Agenda Item: Fullwood Station Administrative Amendment

DATE: April 5, 2016
FROM: Mary Jo Gollnitz

RE: Fullwood Station – Administrative Amendment

**FULLWOOD STATION
 SINGLE-FAMILY SUBDIVISION**
 PROVIDENT LAND SERVICES, INC. | MATTHEWS, NC | MECKLENBURG COUNTY
OVERALL GRADING PLAN

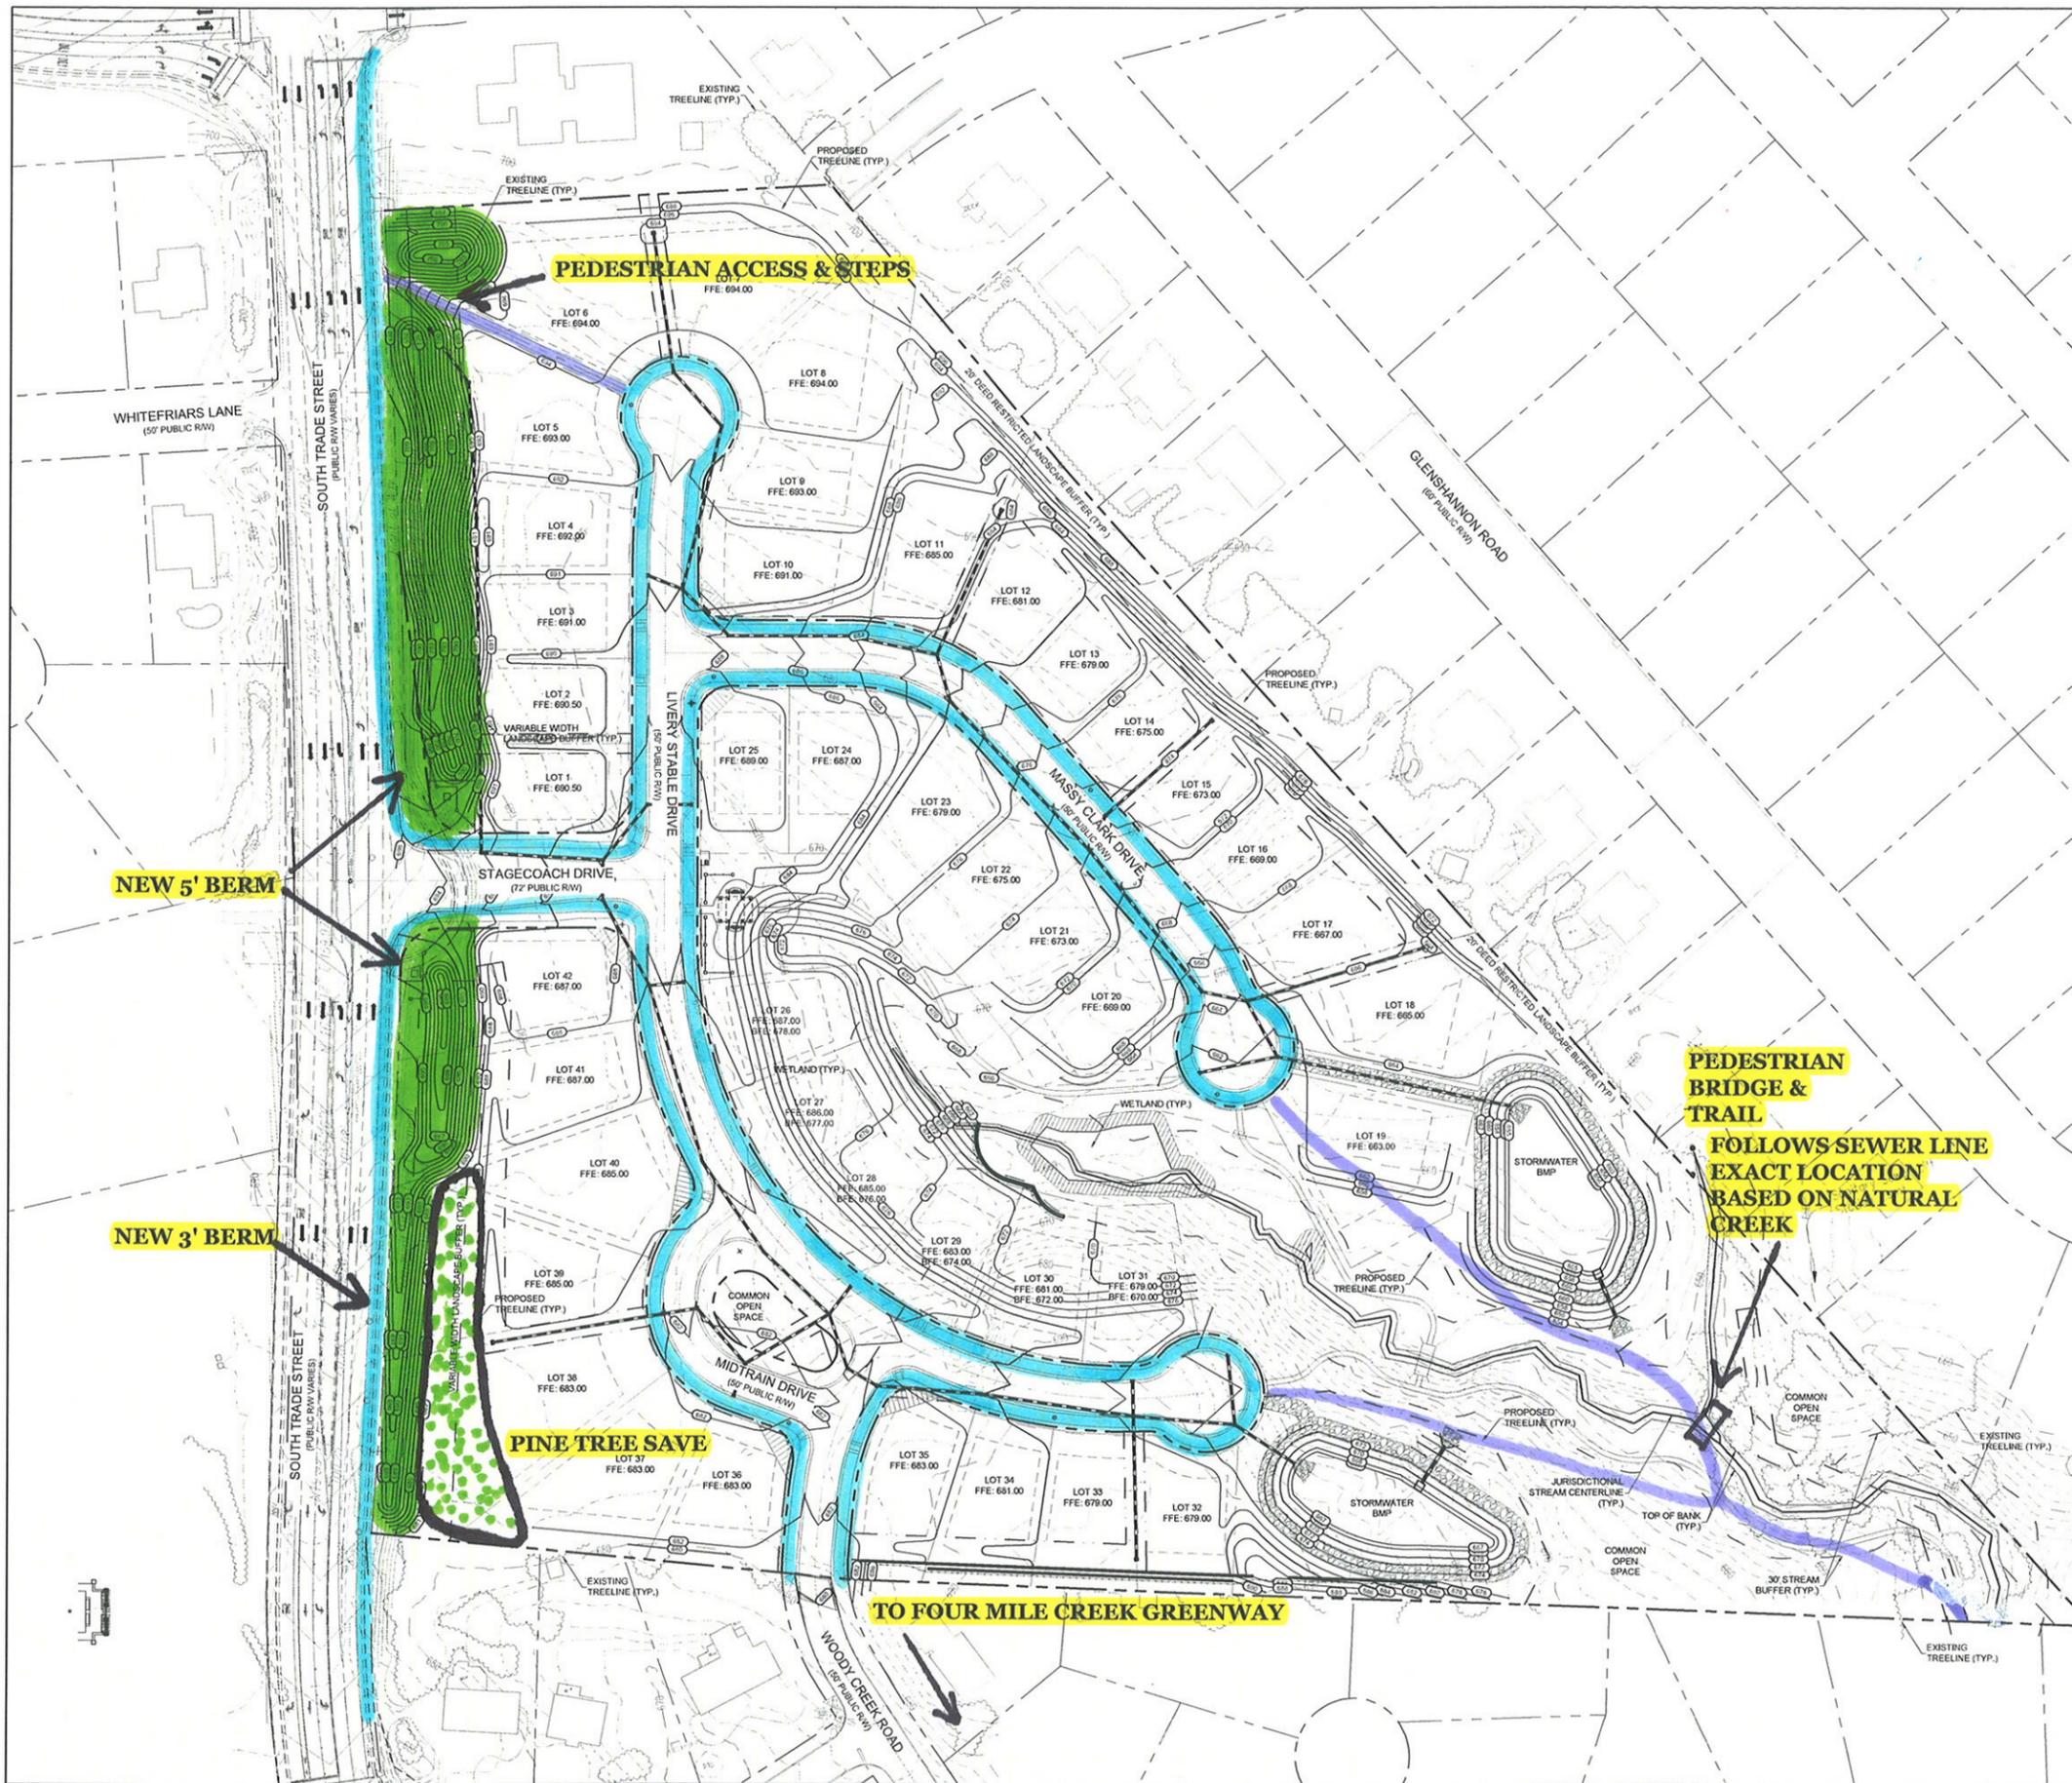
4. Request to keep existing pine trees on South Trade Street next to Chesney Glen neighborhood and remove the existing trees near the Boy Scout property, per the Town Arborists' suggestion. (see map)

5. Request to install fully landscaped 2' to 3' tall sculpted berm in front of existing pine tree save area. Berm will then increase to 5' tall towards the entrance and continue on opposite side of entrance towards the Boy Scout property. Trees and shrubs to meet or exceed the Town's landscaping requirements. Berms to be irrigated on a regular basis by the HOA.

- 3 The cluster of trees that are not exclusively pines. The landscape plans show the approximate location of the tree save area. Matthews Arborist Ralph Ramseur did make a site visit with Mr. Waters and they have agreed on where the 5' berm can start (see attached email). The landscape drawings provided are conceptual only and show the placement for entrance signage.
Staff will review the complete landscape plan separately.
